PWROG-17031-NP, Revision 1
Project Number 99902037

OG-19-184

Subject: PWR Owners Group
Transmittal of the Response to Request for Additional Information, RAIs 1, 2 and 3 Associated with PWROG-17031-NP, Revision 1, "Update for Subsequent License Renewal: WCAP-15338-A, "A Review of Cracking Associated with Weld Deposited Cladding in Operating PWR Plants," PA-MS-1497

Subject: **Westinghouse Response to U.S. NRC Request for Additional Information for the Review of Generic Topical Report No. PWROG-17031-NP, Rev. 1**

Figure 1. K_{Ic} Curve with 200 ksi√in Upper Shelf

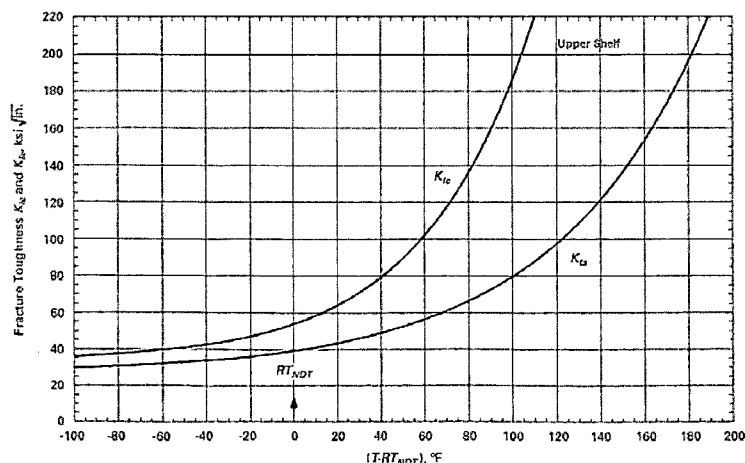
Sections 5.5 and 5.6 of the TR address continued implementation of the same allowable flaw sizes that were previously established for 60-year applications in WCAP-15338-A (October 2002, ML083530289). This is based on consideration of the same governing transient characteristics for 3-Loop plants, as well as the continued use of time-invariant upper shelf fracture toughness (K_{Ic}) of 200 ksi√in for all transient analyses.

In order for an assumed K_{Ic} fracture toughness of 200 ksi√in to remain valid for 80-year applications, the RPV metal temperatures for all transients evaluated in the TR shall exceed the limiting adjusting RT_{NDT} values for the analyzed flaw depths by at least 104.25 °F; this is based on the K_{Ic} curve provided in the ASME Code, Section XI, Appendix A.

Request:

Considering that RPV beltline neutron embrittlement will result in significant shift in the RT_{PTS} and RT_{NDT} values for 80-year applications, please justify the continued use of 200 ksi√in as the generic RPV beltline material fracture toughness for determining the allowable flaw sizes for Level C and D service conditions in Section 5.6 of the TR.

PWROG-17031-NP [2] and WCAP-15338-A [1] calculate K_{Ic} , fracture toughness per ASME Section XI, Appendix A, A-4200. It is noted that K_{Ia} was not used in the underclad cracking evaluation. Since there is no prescribed upper limit in the ASME code, 200 ksi√in was conservatively used as a maximum value (or "upper shelf"), even if the calculated K_{Ic} is higher per the ASME Section XI, Appendix A, A-4200 formula. See Figure 1 for a visual demonstration of the 200 ksi√in value superimposed on the ASME Section XI, Appendix A K_{Ic} curve.

All limiting transients for normal, upset, and test conditions have high fluid temperatures, and the calculated K_{Ic} exceeds 200 ksi $\sqrt{\text{in}}$ even if the 10CFR50.61 PTS screening criterion of 270°F is used. Therefore, K_{Ic} was limited to 200 ksi $\sqrt{\text{in}}$ to maintain conservatism and be in line with industry practices.

For transients of emergency and faulted conditions (Level C and D transients), if $T - RT_{NDT} > 104.25$ °F, 200 ksi $\sqrt{\text{in}}$ is used; otherwise, the K_{Ic} equation per A-4200 is used.
